08-AFC-4

RE: Proposed Modification to Condition of Certification BIO-7

**Figure depicting the design layout for the bore pit and exit pit
and 300 foot distance from southern riparian forest**

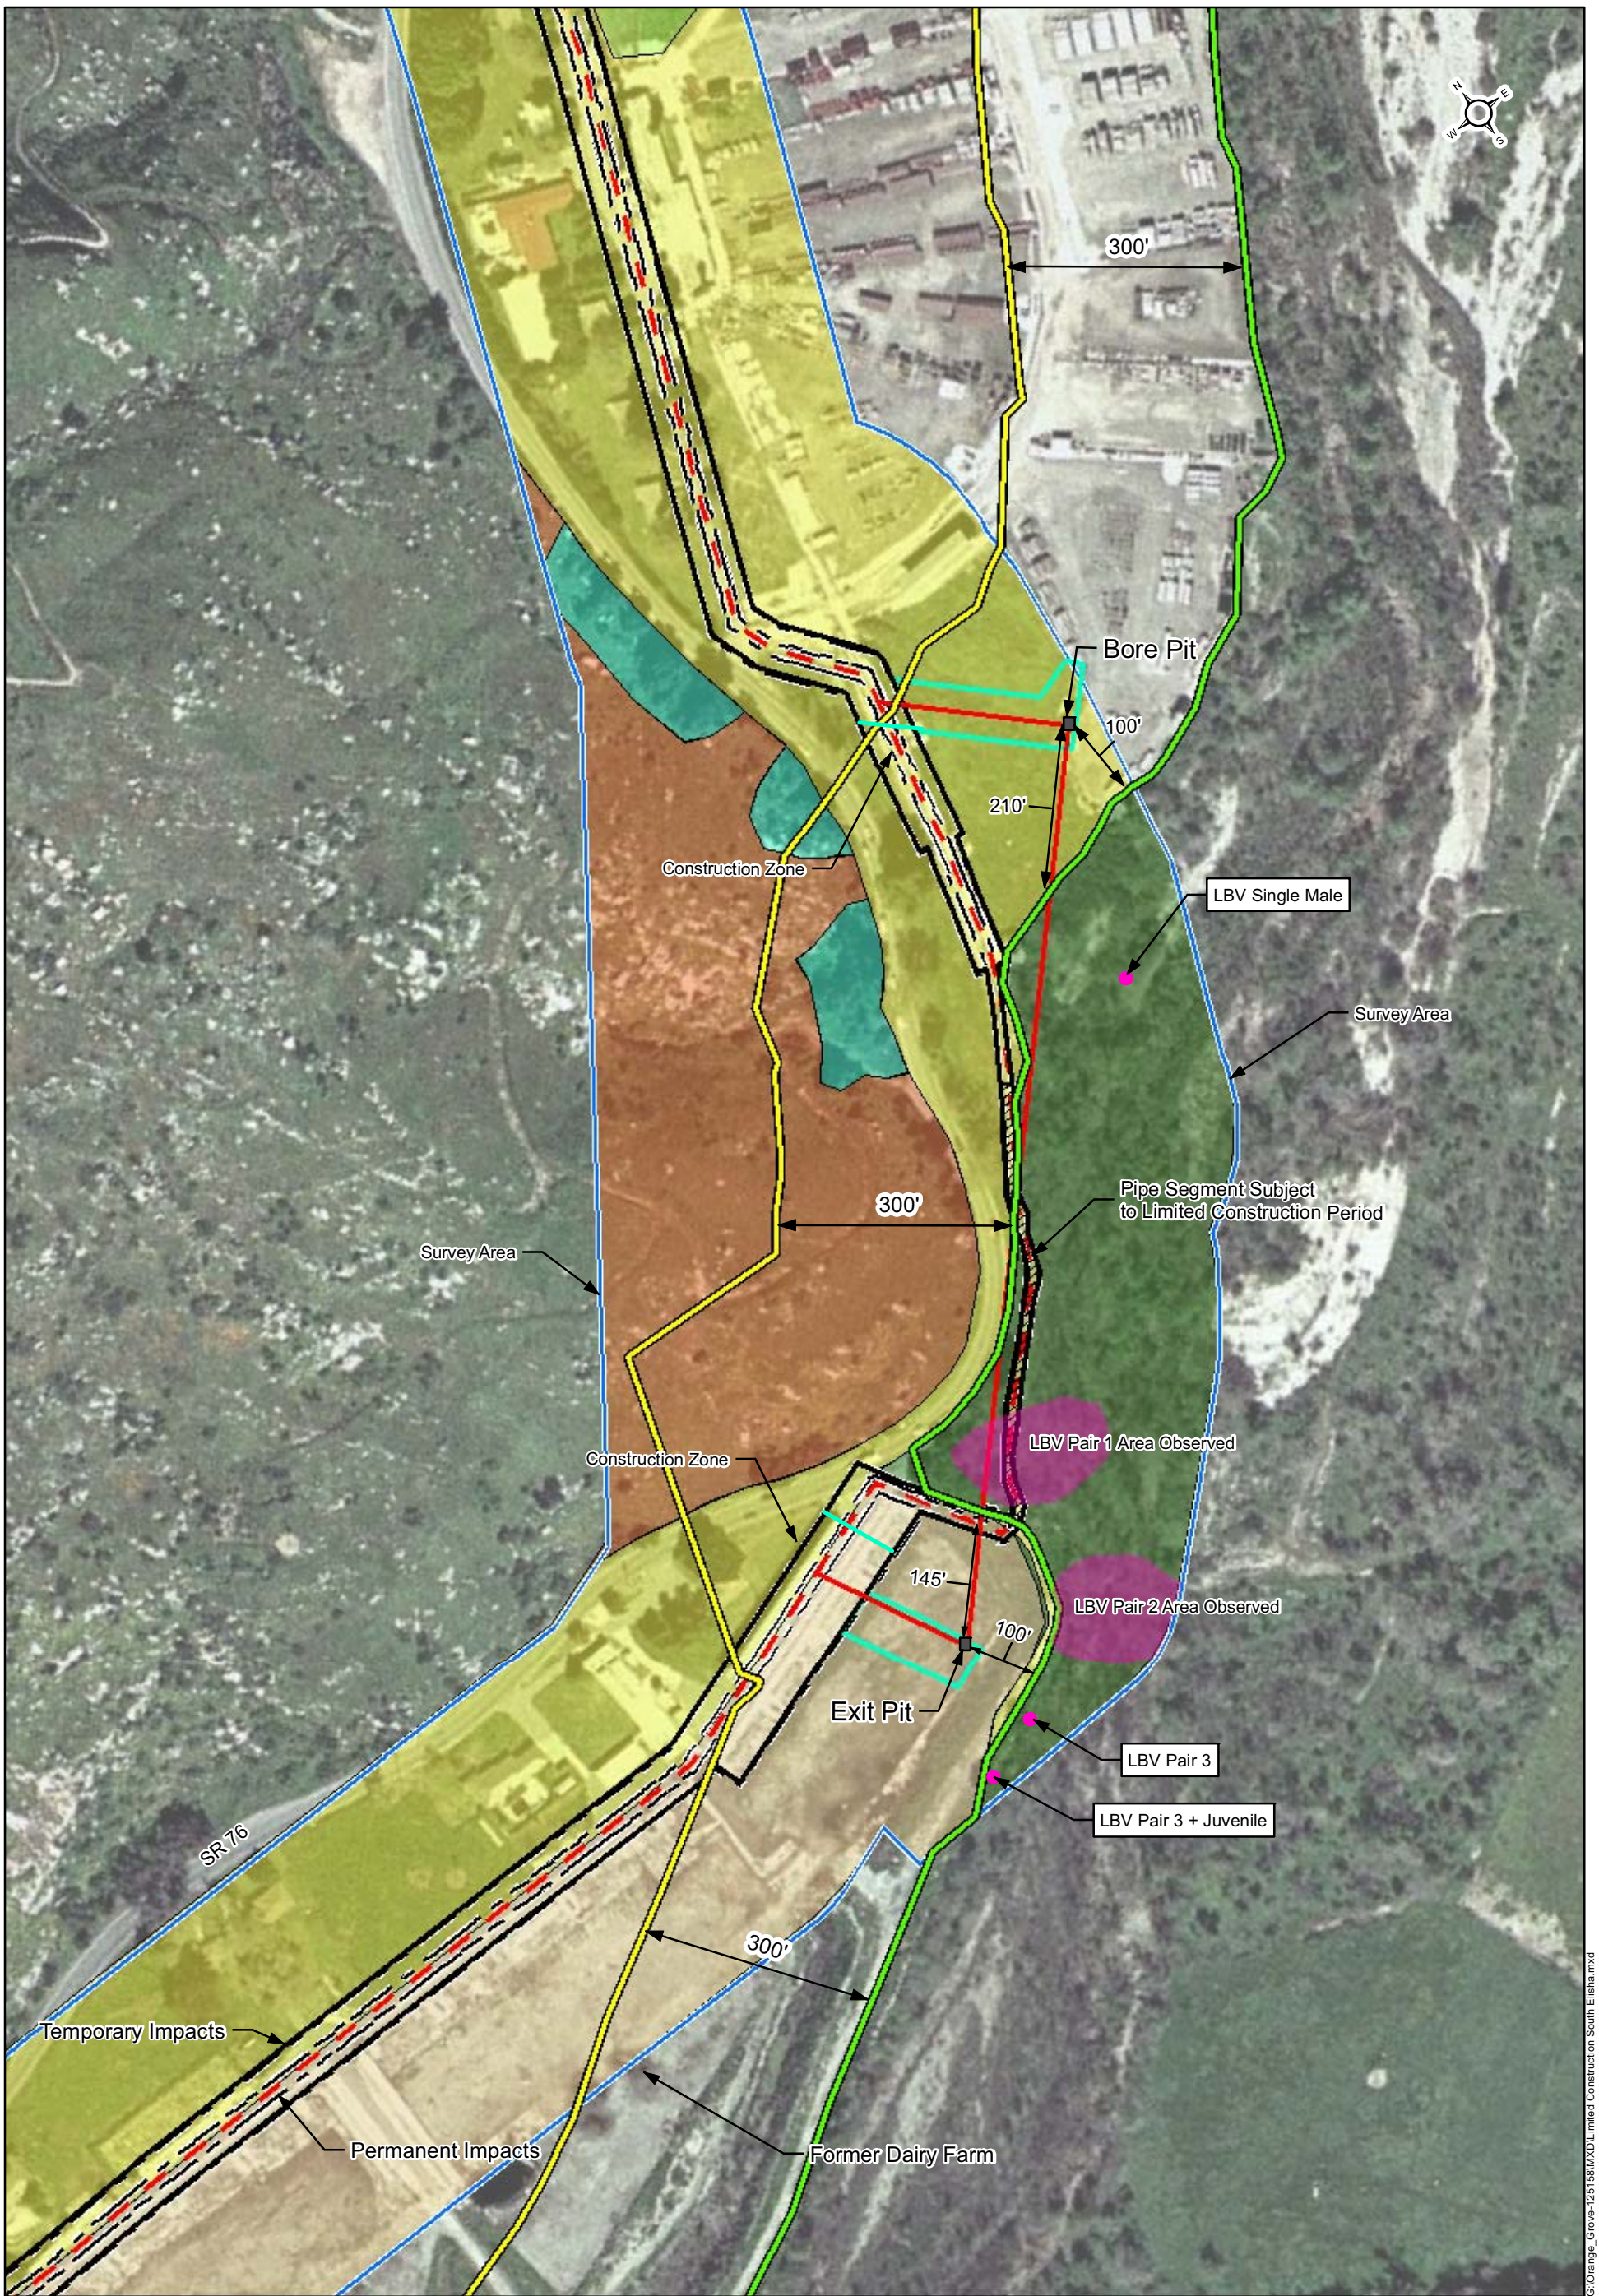
As shown on the graphic included in Attachment A, it is not physically possible to locate the boring pit and receiving pit for the horizontal boring 300 feet away from existing riparian habitat. The figure in Attachment A graphically depicts on an aerial photograph the existing southern riparian forest area located between the two former dairy sites within the project area, and the location of the bore pit and exit pit as proposed in the project design drawings. Attachment A also shows the 300 foot distance from the riparian habitat depicted in the attachment as a yellow line. To extend the bore to the southwest would put the exit pit closer to riparian habitat. To extend the bore to the northeast could achieve some additional setback, but there is no way to get the bore pit 300 feet from the riparian habitat. Extending the bore to the northeast would increase

the length of the bore and result in horizontal boring rig use and human presence in the vicinity of the riparian habitat occurring over a longer period of time.

Based on the above information, J-Power is proposing to revise Condition of Certification **BIO-7** in CEC's Staff Assessment. The proposed revision is included as Attachment C. As discussed above, the primary change is to reduce the setback from riparian habitat from 300 feet to 100 feet to match the project design presented in the Application for Certification, with additional measures to mitigate the potential impact to sensitive species that could be located in the riparian habitat using a temporary visual barrier and sound curtain.
